CITY OF ROCKWALL
Historic Preservation Advisory Board Memo

AGENDA ITEM: H2007-001; 501 Munson

Hold a public hearing and consider a request for a Certificate of Appropriateness (CofA) from Kris Hargrove for the alteration/replacement of an existing porch, shutters on front porch windows, and replacement of existing metal skirting at 501 Munson Street (Monnie Rodgers Subdivision, Lot 1). The tract is zoned (SF-7) Single Family Residential and is located within the Old Rockwall Historic District and identified as a "Medium Contributing Property."

RE: H2007-001
501 Munson
Project Type: HISTORIC (C of A)

Star Trim Brackets

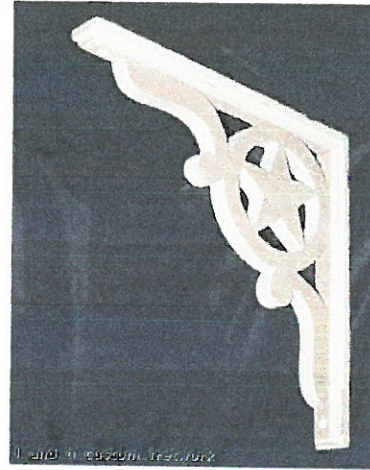
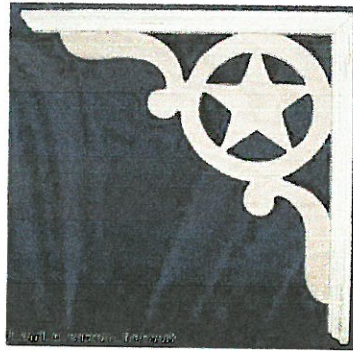
The applicant is proposing to rebuild the deteriorated porch in a Victorian style as submitted in the attached photos and drawings. Included with rebuilding the porch will be the addition of porch rails. Attached to the newly reconstructed porch will be Victorian Gingerbread Star Trim Brackets as shown in the attachments. The application does not include any alteration to the existing roof or roof line.

- 1. Porch railing to be a maximum 28" in height.*
- 2. Porch rail support post to be turn-post balustrades.*
- 3. All four porch columns to be 8" x 8" and flat/square.*
- 4. Concrete sidewalk in front yard to be a maximum of 3' in width.*
- 5. The height and width of the shutters should be proportional to the window and appear as if they could close over the window.*
- 6. Hardiboard used for the skirting to match the existing wood siding in finish and reveal.*
- 7. The storm door located at the front to be wood frame.*

Builders Edge Pair of 15 In. x 75 In. Louvered Shut Black

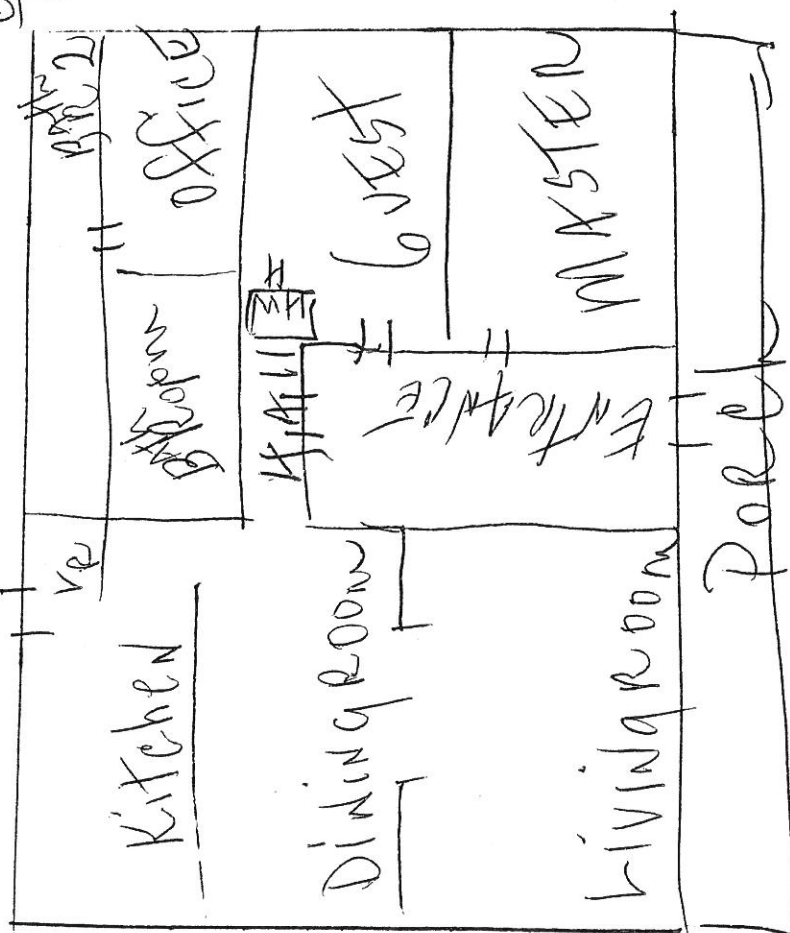
The CofA application also request that shutters be added to the windows along the front porch. Staff feels that the height and width of the shutters should be proportional to the

window. If the shutters are affixed the proper proportion would give the appearance that they fit the window openings.

1. Adherence to the standards and regulations of the Building Inspection Department.
2. The width of the skirting be determined before approval.
3. The height of the porch railing be determined before approval.
4. The height and width of the shutters should be proportional to the window
